## DSAX96204Q-01

# S E R V I C E N O T E

## DSAX96204Q Infiniium High-Performance Oscilloscope: 63 GHz

Example of the data flyers:

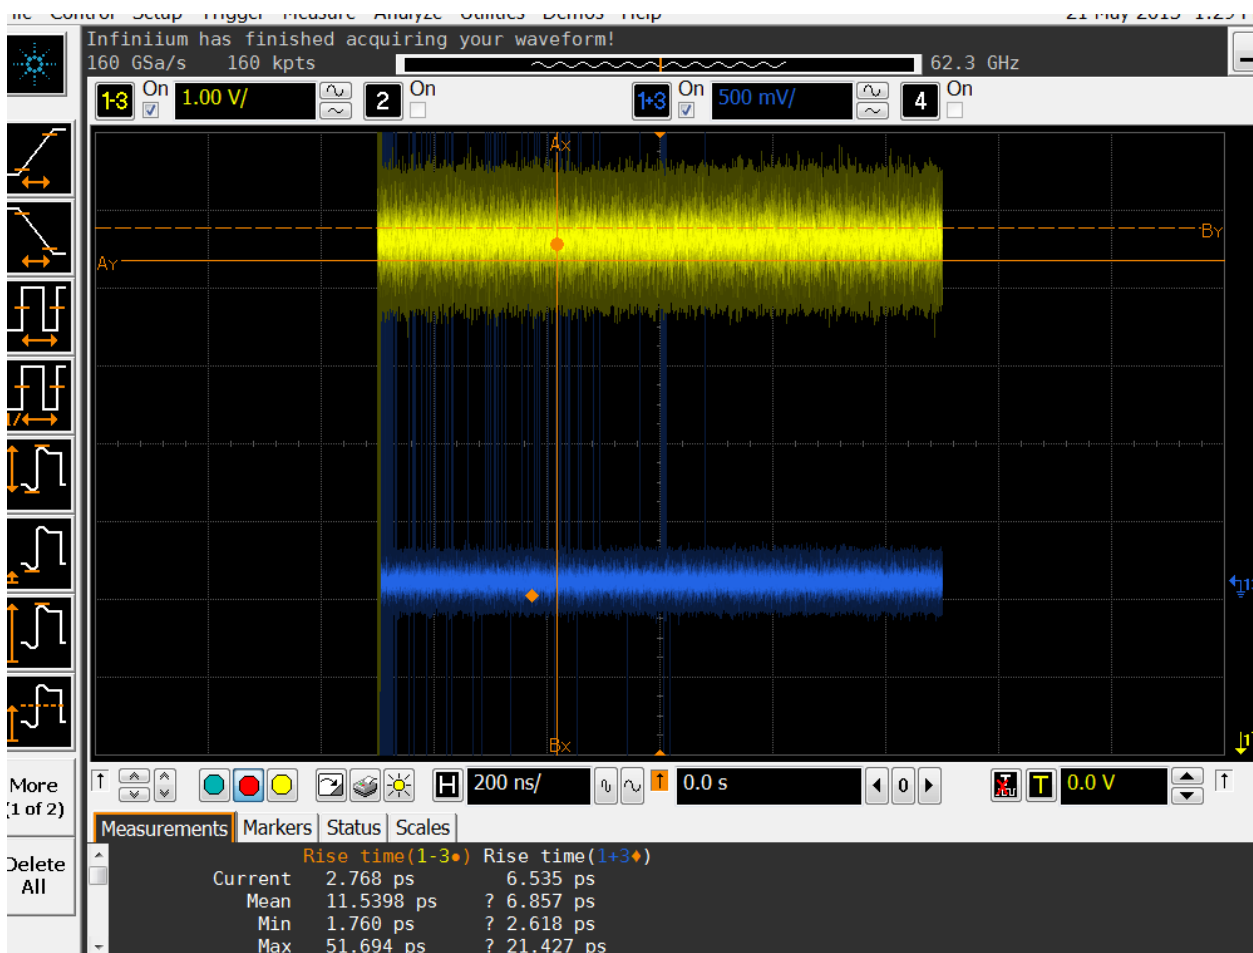
Using the Real Channels with differential mode on and or Precision Probe on, causes the Main FPGA to dip and data fryers are observed due to voltage variations.

Starting in July 2013 week 33 and ECO was implemented changing the power supplied to the Main FPGA. This fixed the Real channels having Data Flyers due to voltage variations. Scopes shipped previous to this ECO need to be updated to the reworded Backplane assembly.

Replace Backplane assembly following the service manual procedure. Factory Calibration is required after the backplane replacement.
